PROJECT: Bethesda Market
Sketch Plan No. 320190030

*The **Bethesda Market** project was reviewed by the Bethesda Downtown Design Advisory Panel on **October 24, 2018**. The following meeting notes summarize the Panel's discussion, and recommendations regarding design excellence and the exceptional design public benefits points. The Panel's recommendations should be incorporated into the Staff Report and strongly considered by Staff prior to the certification of the Site Plan. Should you have any additional questions and/or comments please feel free to contact the Design Advisory Panel Liaison.*

PROJECT: Bethesda Market
Sketch Plan No. 320190030

*The **Bethesda Market project** was reviewed by the Bethesda Downtown Design Advisory Panel on **Wednesday, September 25, 2019**. The following meeting notes summarize the Panel's discussion, and recommendations regarding design excellence and the exceptional design public benefits points. The Panel's recommendations should be incorporated into the Staff Report and strongly considered by Staff prior to the certification of the Site Plan. Should you have any additional questions and/or comments please feel free to contact the Design Advis

BELOW GRADE PARKING

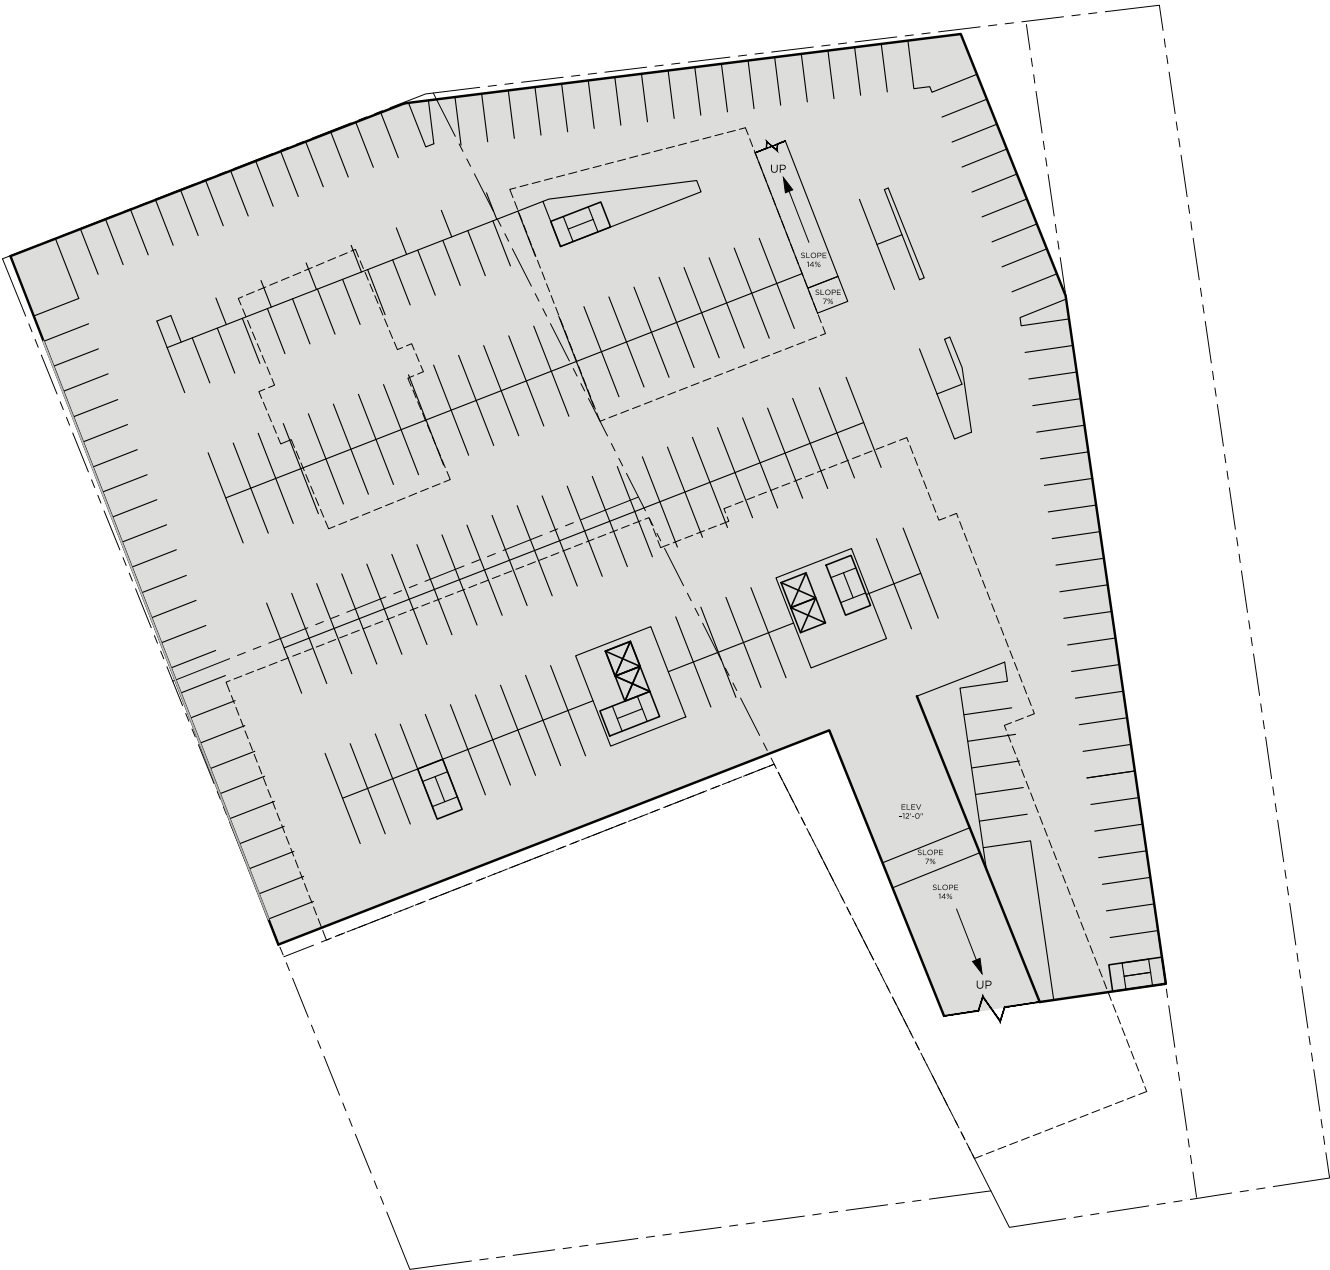
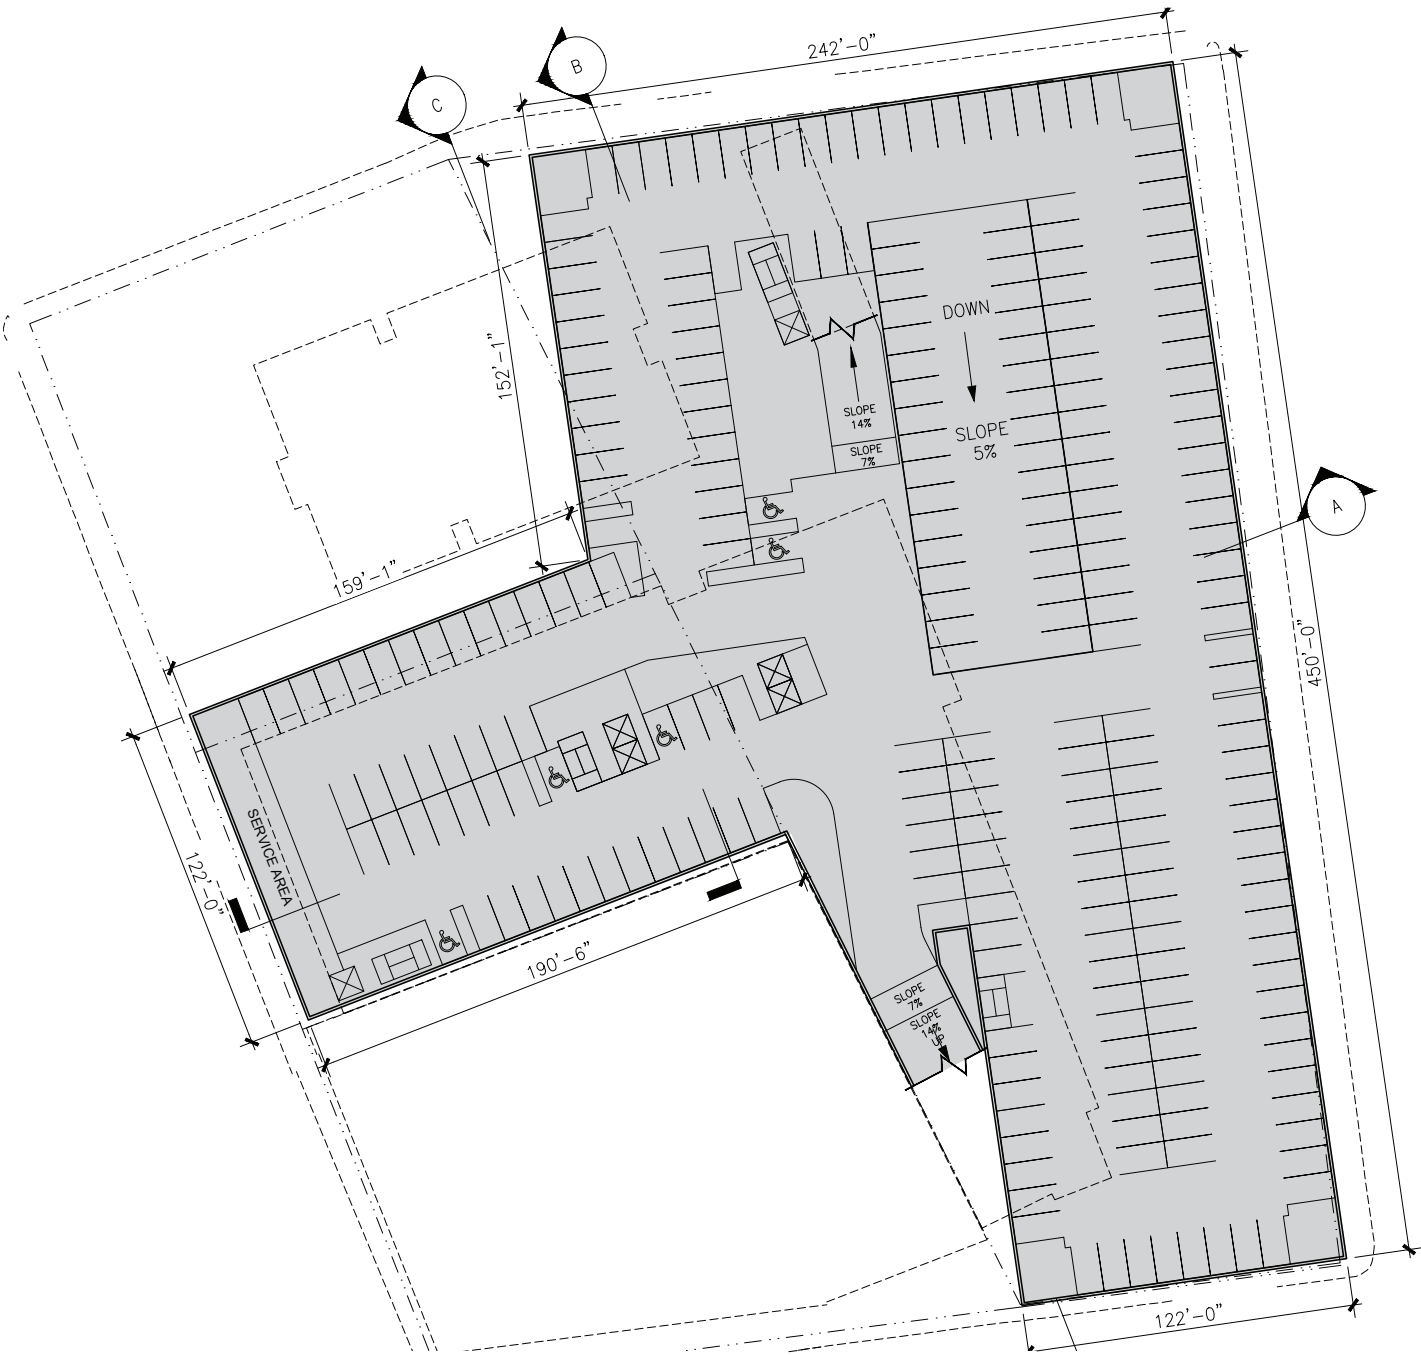
- The garage access points and paving details are shown differently on the overall plan.
 - *Applicant response:* That was an oversight. We are also trying to figure out how to make the garage ramp from Willow disappear or blend into the landscape, while provide options to get in and out of the site.

- With the expansion of the garage to the north/east, how will it be possible to get large trees. The new park needs the trees to be big.
 - *Applicant response:* There is significant grade change, so there will be a soil depth to allow large trees.

- Reconfigured Below Grade Parking
- Eliminated Most of the Parking Below the Farm Women’s Market Site
- Increased Efficiency

DESIGN CONCEPT STUDIES FOR MASSING / ROOF FORMS/ FENESTRATIONS

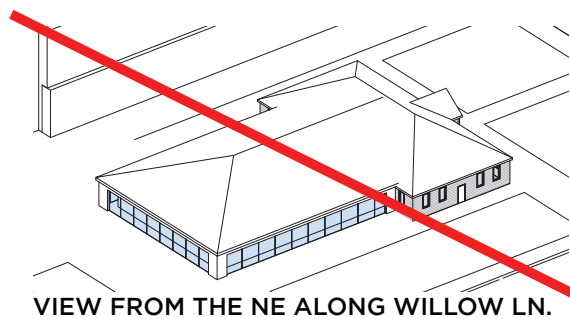
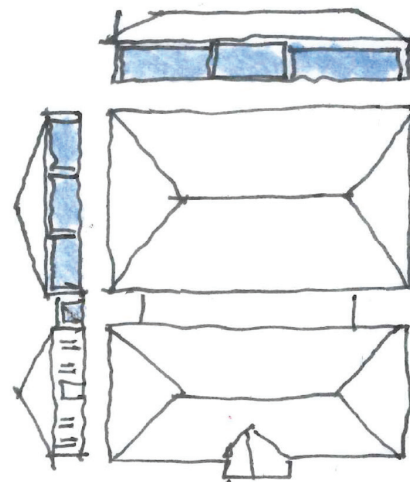
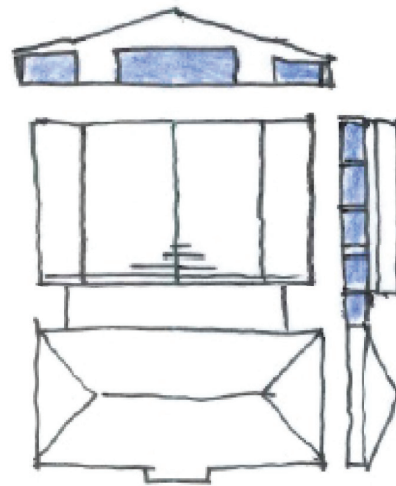
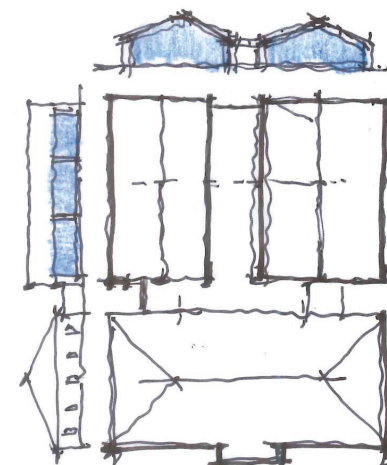
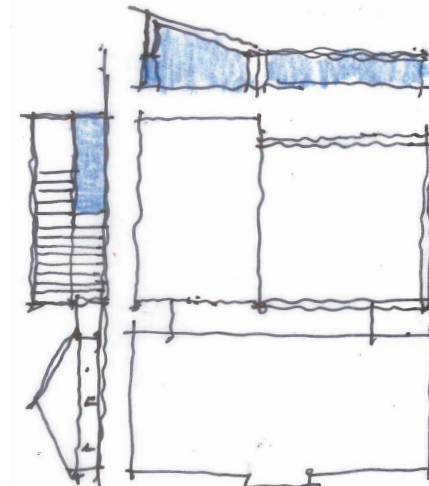
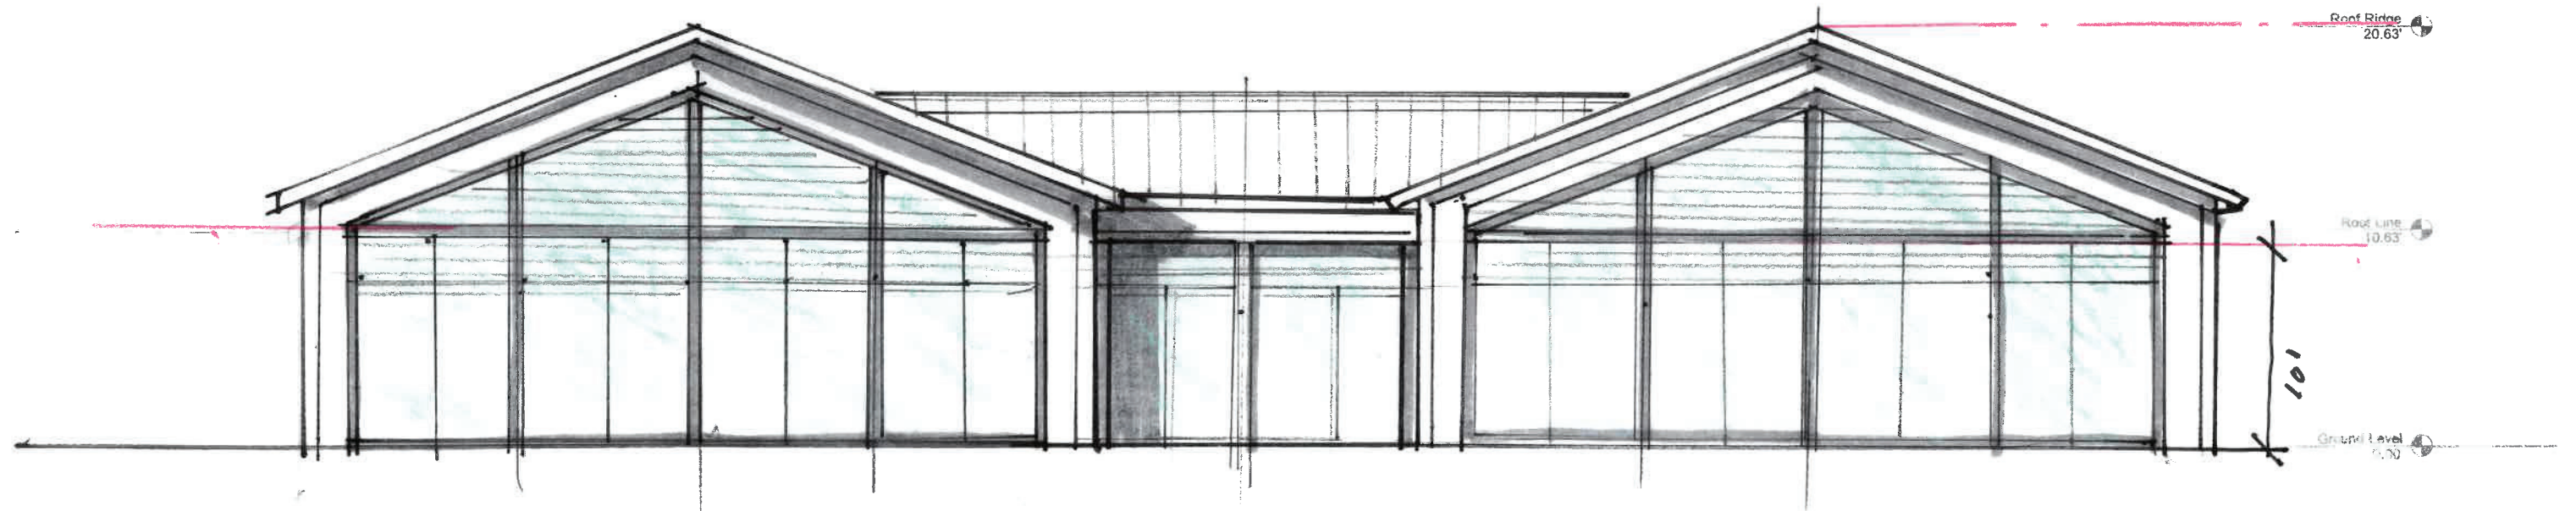
- The 10' datum line for the proposed addition to the Farm Women's Cooperative Market maybe too short to function as a great market building.
 - *Applicant response:* They will continue to work with the Historic Preservation Commission (HPC) and would like the form to read on the exterior of the building but take advantage of the interior volume in the middle.

- Shed dormers may work better for the building addition, getting rid of the intermediate truss may provide flexibility on the inside of the structure.

- A hyphen between the existing Farm Women's Cooperative Market Building and the new addition will help differentiate and expand what is usable.
 - *Applicant response:* Feedback from the Panel will be conveyed to the HPC.

1. Shed dormers may work better for the building addition, consider getting rid of the intermediate truss to provide flexibility on the inside of the structure.
2. Provide all elevations of the Market addition for review.
3. The symmetrical elevation of tower is too predictable, consider making asymmetrical to emphasize the base wrapping around the corner onto Wisconsin, and emphasize the transition back to park.

- The Panel would like to see all of the elevations for the addition to the Farm Women's Cooperative Market.
 - *Applicant response:* They will continue to work with the Historic Preservation Commission on design options and suggestions from the Panel.

INCREASED PARK SPACE ON LOT 24

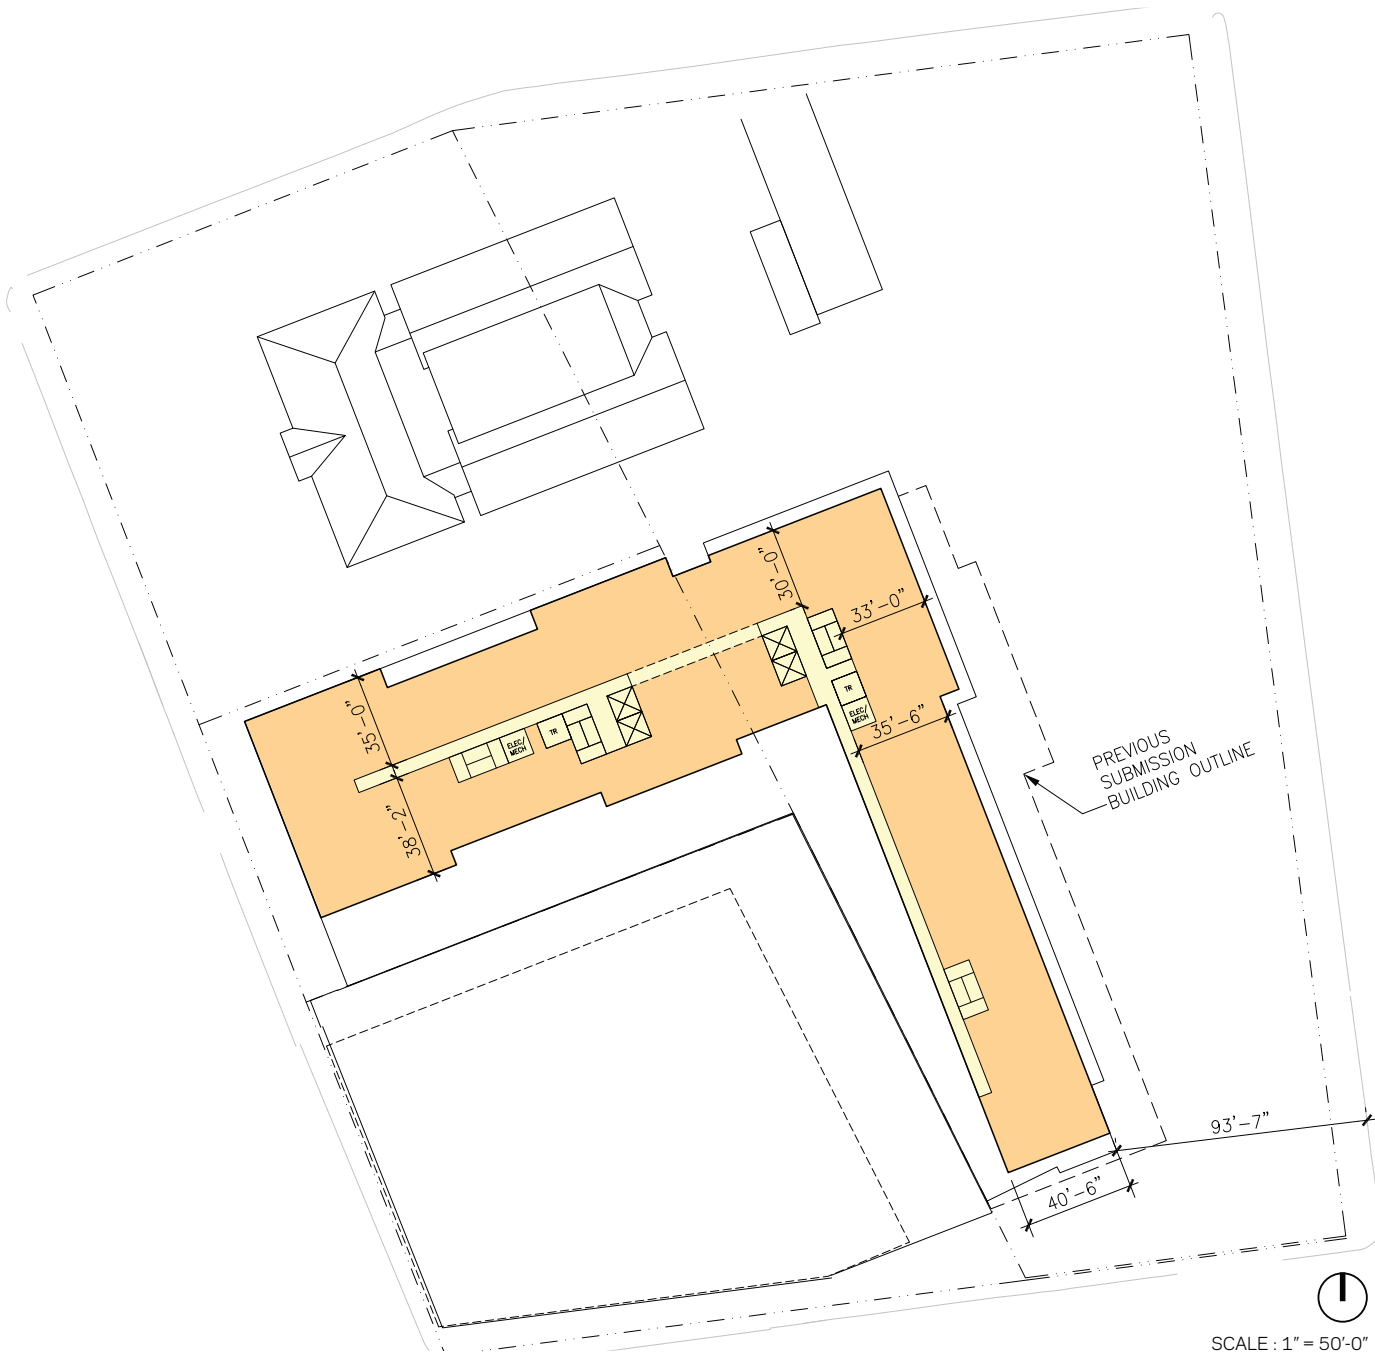
- The Site Plan has improved greatly, the single loaded corridor that faces the proposed park on Parking Lot 24 is a much better design, the ground plane has improved.

- Substantially Reduced Building Footprint on Lot 24 with a Single Loaded Hallway Configuration
- Increased Park Space on Lot 24
